March 4, 2002

**SUBJECT: Temporary Design Bulletin C02-03
Effective March 1, 2002**

FDOT NOISE WALL PILE/POST CONNECTION OPTIONS – GENERAL NOTES (Page 1 of 1)

**NOISE BARRIER WALL.
(REV 2-20-02)**

FDOT NOISE WALL PILE/POST CONNECTION - OPTION NO. 2B (Page 1 of 3)

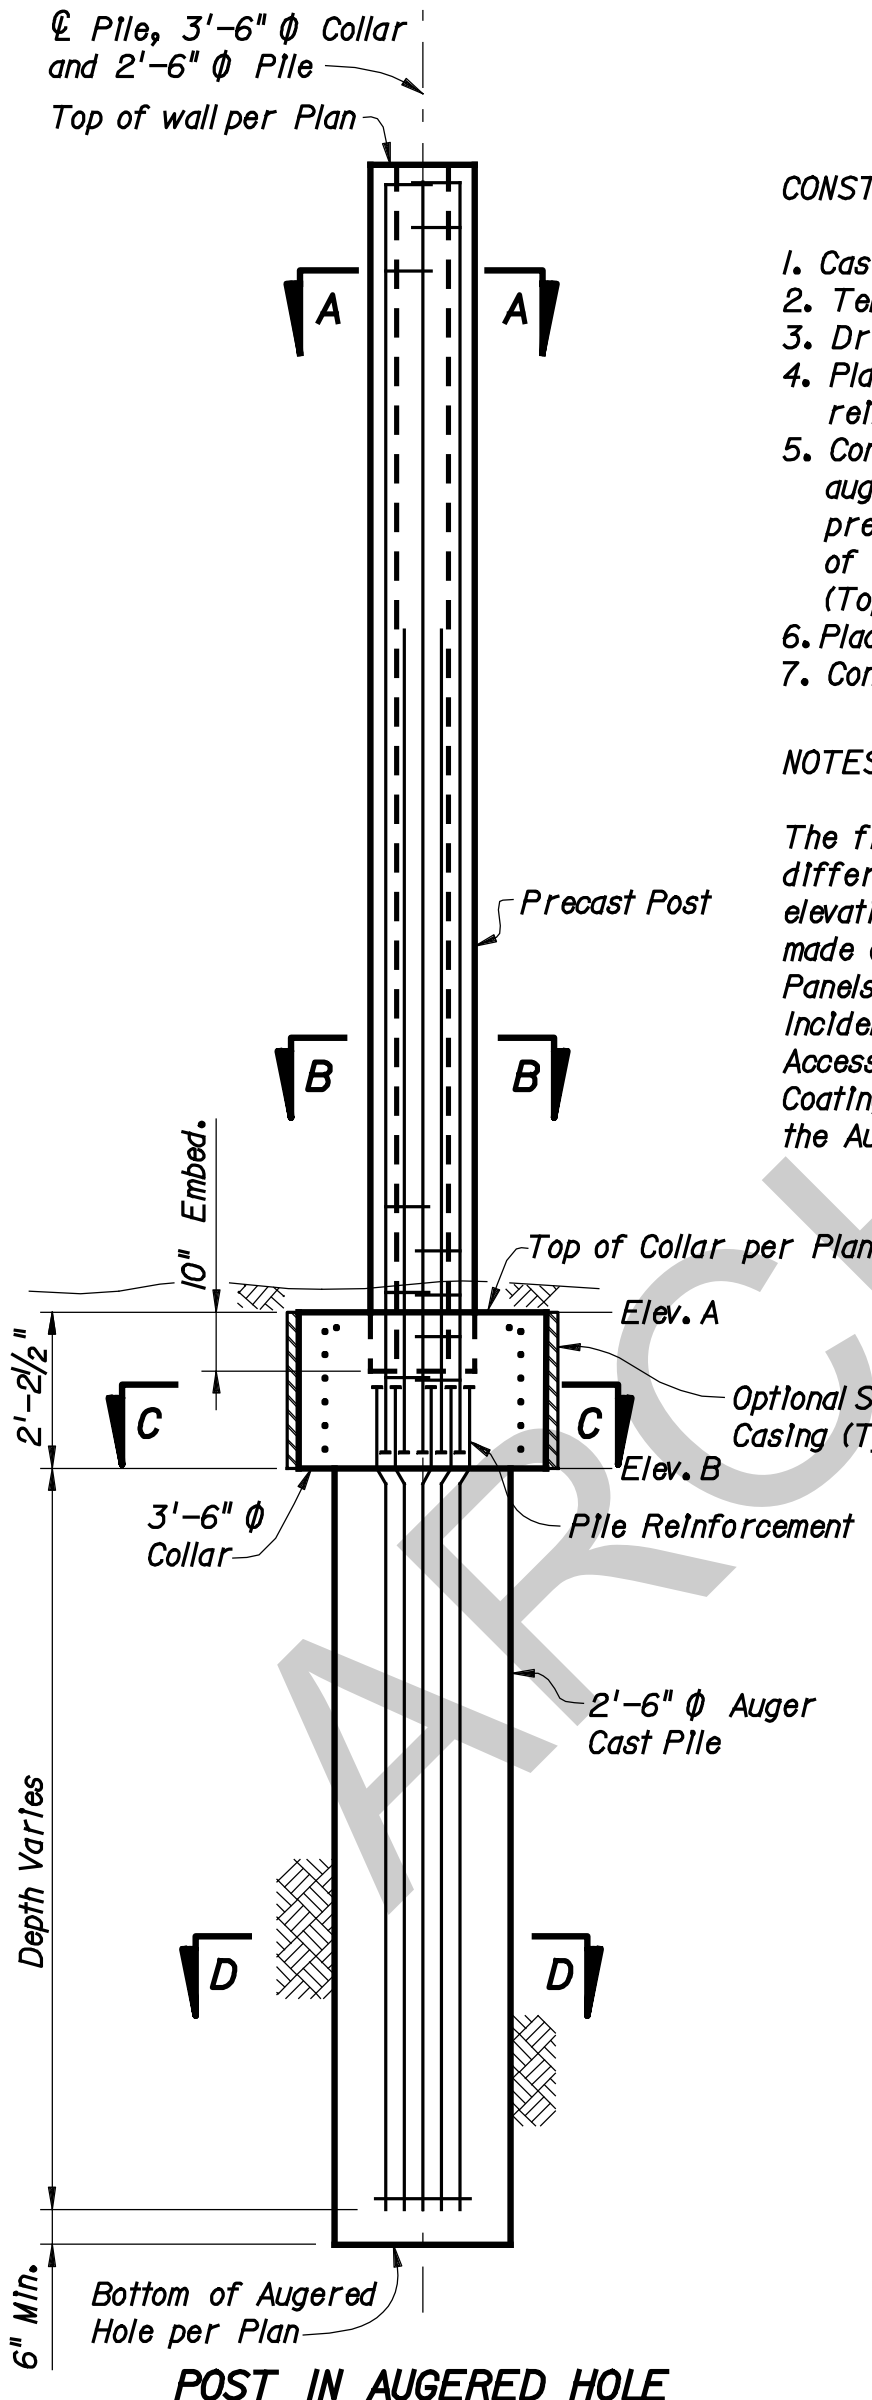
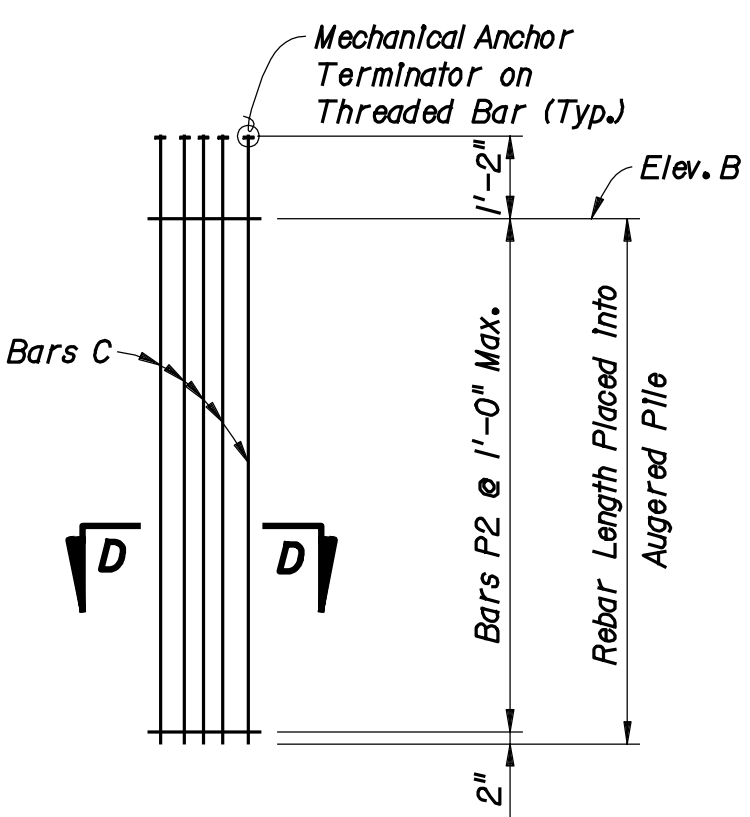
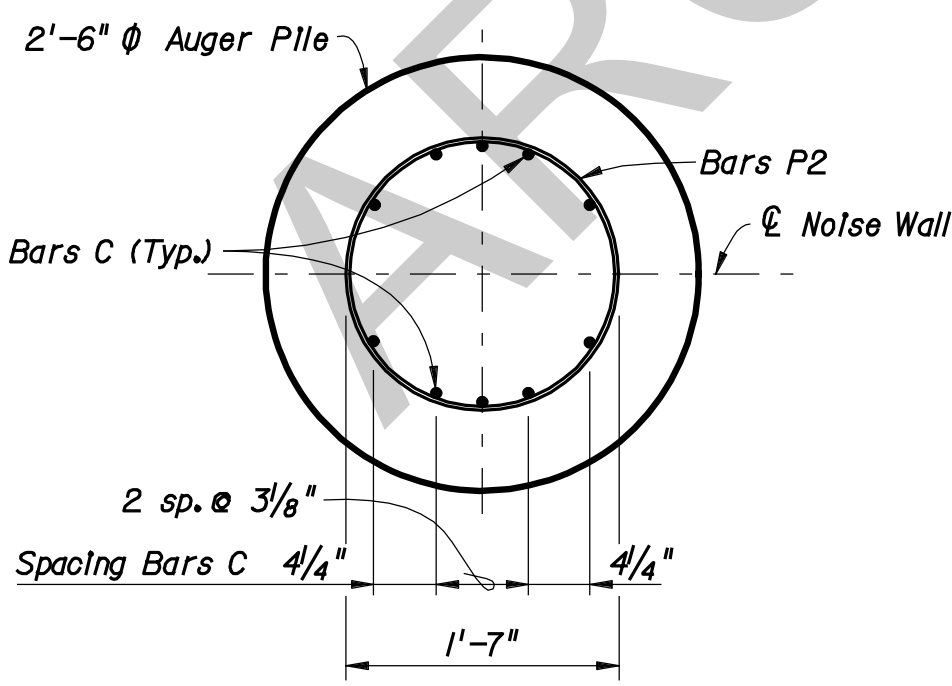
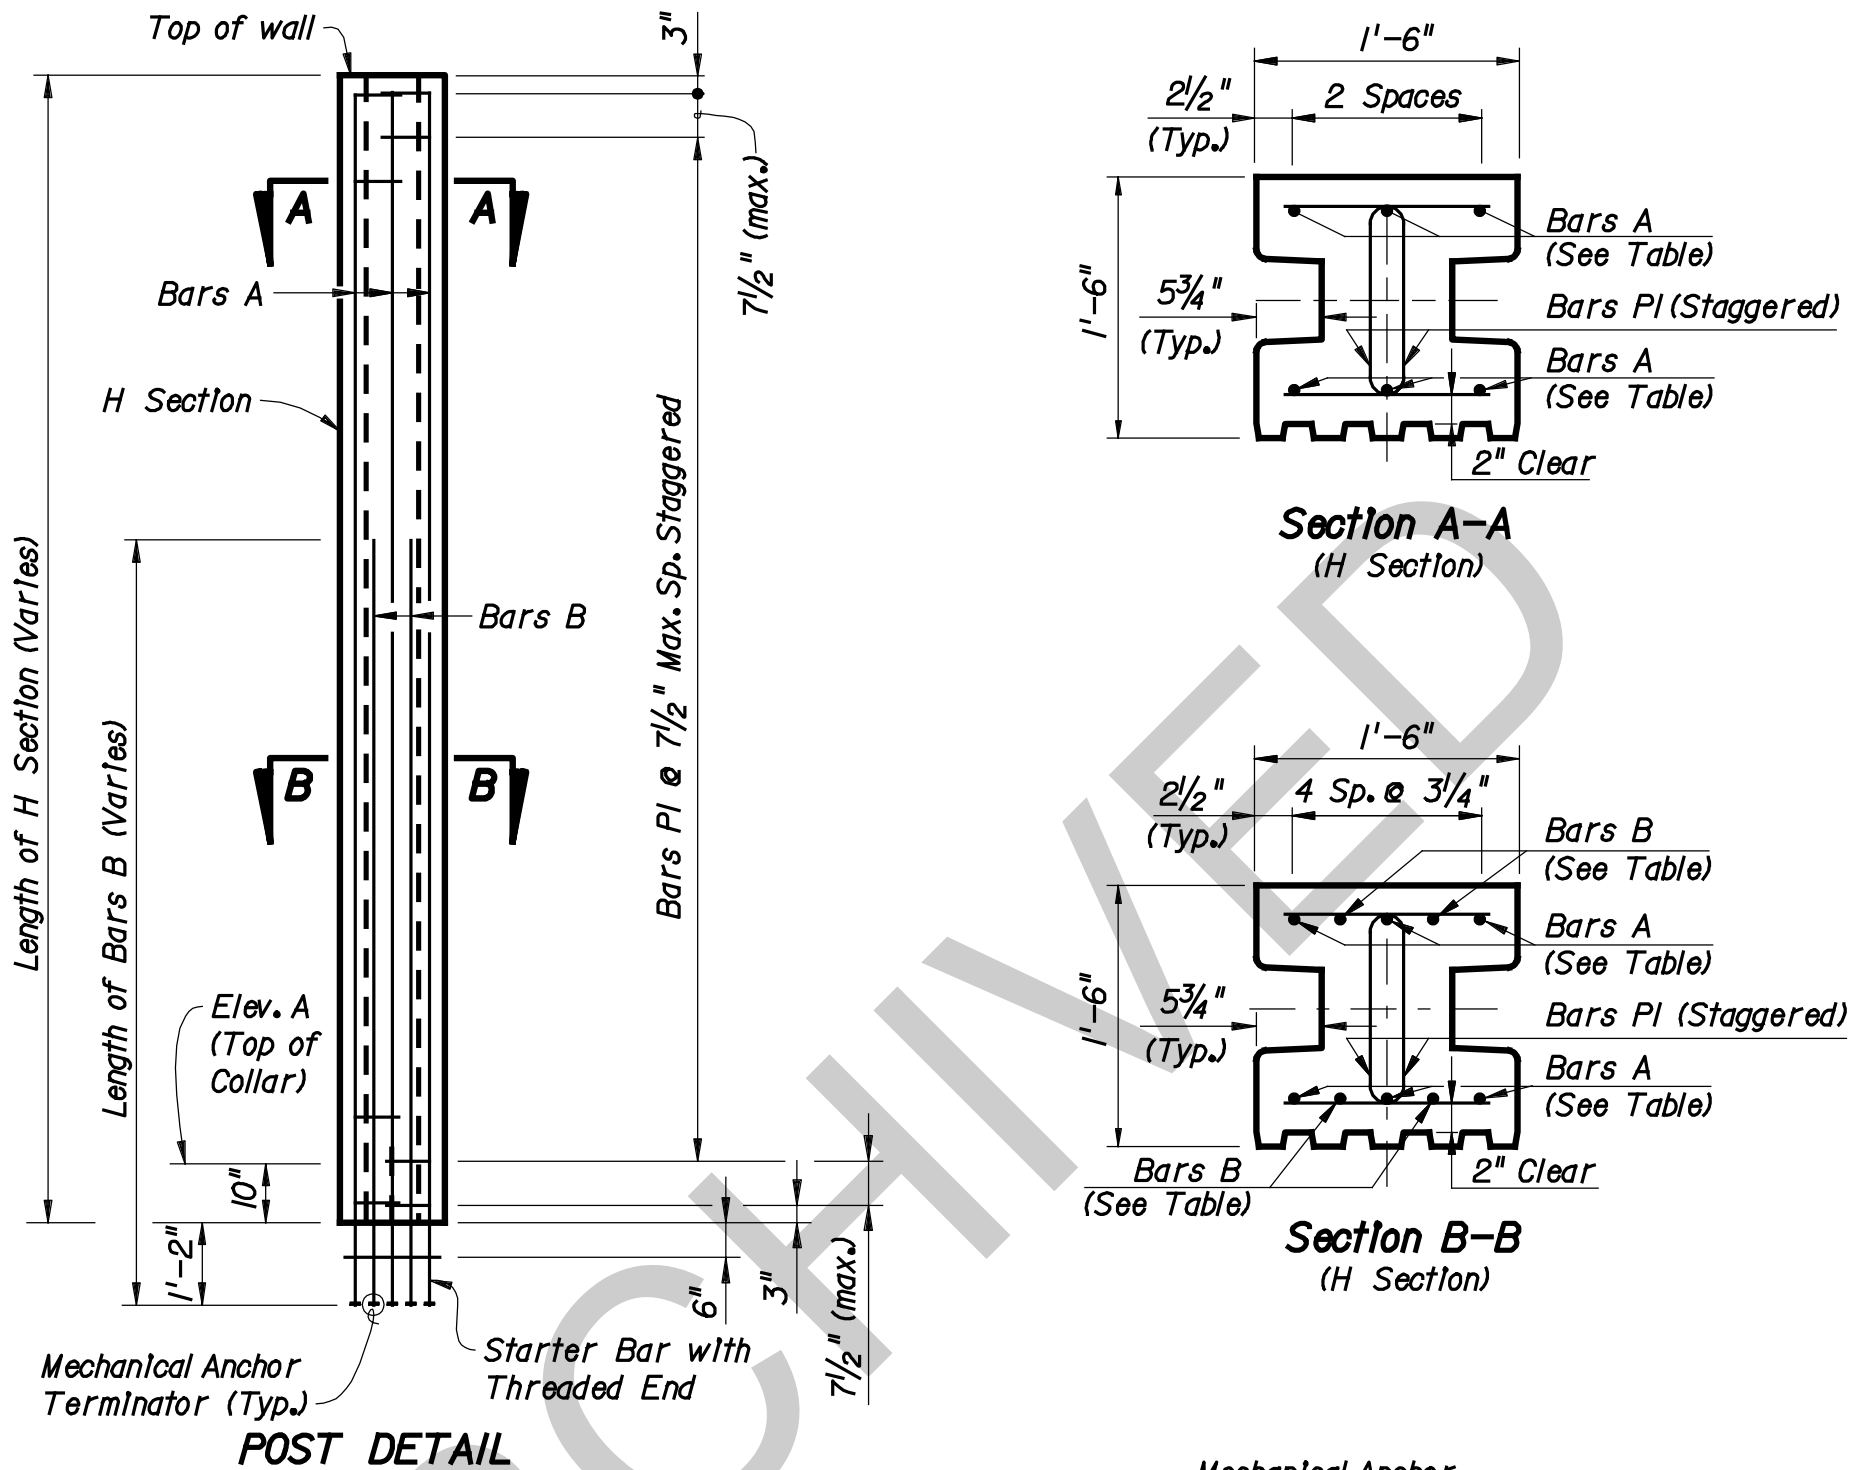
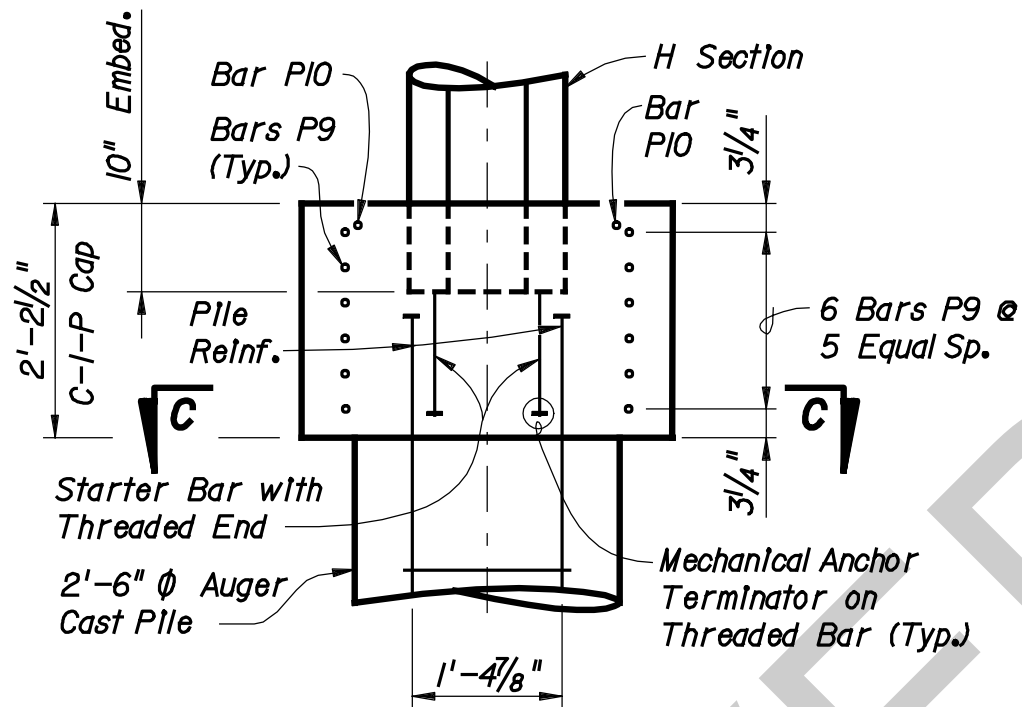
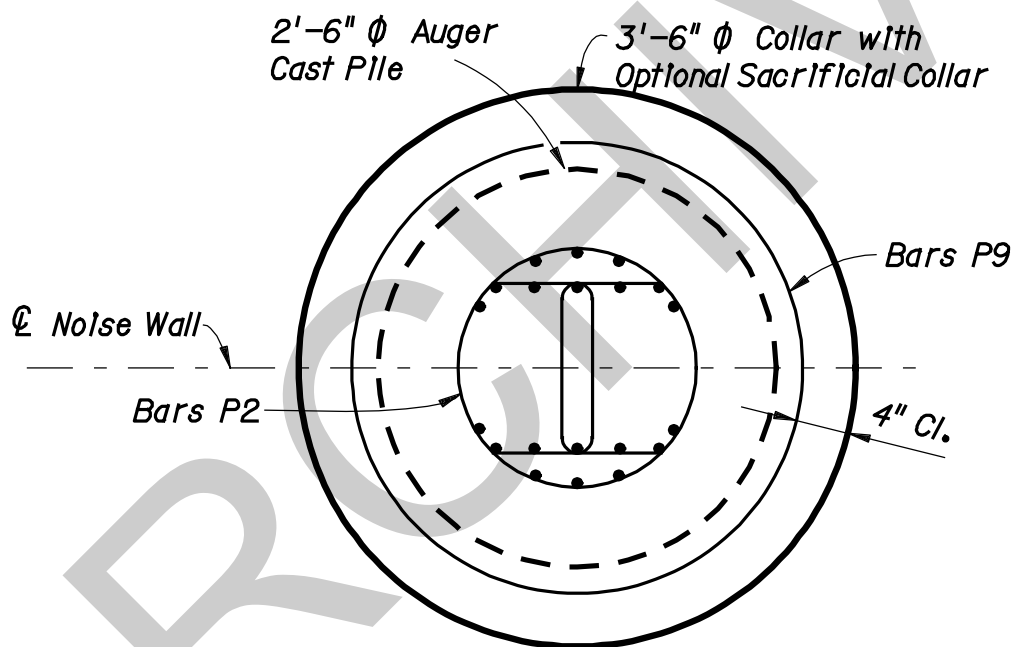
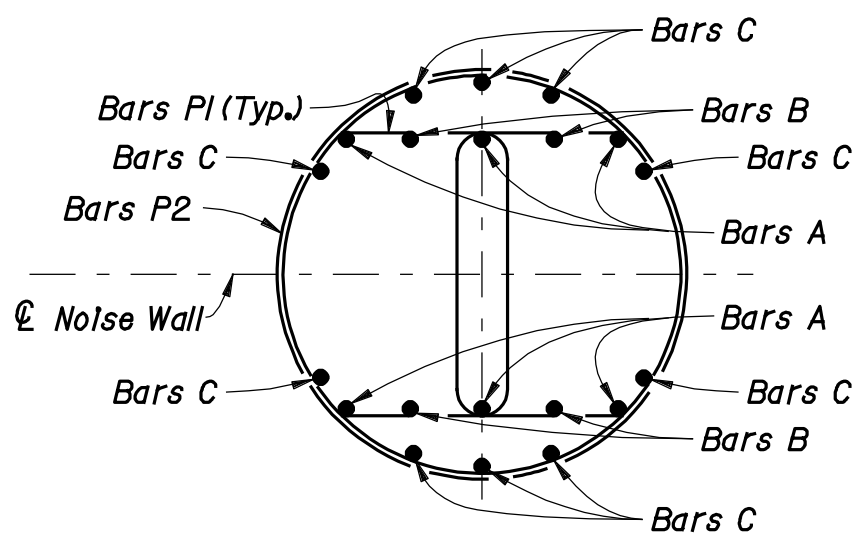
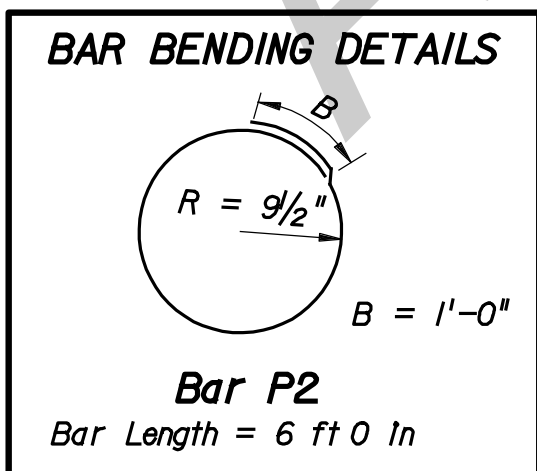
Requires cutting Reinforcement Bars A and B, in the post 1'-2" minimum below the bottom of post. The cut-offs of Bars A and B may be used as Bars C to form a cage using the P2 tie bars. Additional reinforcement Bars P2 shall be provided as shown in Augured Pile Reinforcement Detail on Page 2 of 2 of Option 2B, shown in the attached Appendix. Bars P2 shall be number 4 bars, 6'-1" long and bent to a 9 $\frac{1}{2}$ " radius. If the pile cage is made from Bars A and B cut-offs, then the pile cage shall be raised to 1'-2" minimum above Elevation B. Otherwise Bars C shall be provided to lengths shown and shall be the same bar size as Bars A and B.

The top of all Bars C and the bottom of all Bars A and B shall be threaded and a mechanical anchor terminator installed in accordance with the manufacturer recommendation. The mechanical anchor terminator shall be submitted for approval.

1. Cast the concrete H Post. See post detail on Page 2 of 2.
2. Temporarily excavate to Elev. B in the vicinity of the post.
3. Drill and cast a 2'-6" ϕ auger pile to Elev. B.
4. Place the rebar into the 2'-6" ϕ augered pile hole. See augered pile reinforcement Page 2 of 2.
5. Construct a template to properly align the precast post over the augered pile. Using mechanical anchor terminators connect the precast post rebar with the rebar in the augered pile. The bottom of the H Post section (see section A-A) shall be 10" below Elev. A (Top of Collar).
6. Place the sacrificial casing or collar form and collar reinforcement.
7. Construct a 3'-6" ϕ collar. Finish the concrete to Elev. A (Top of Collar).
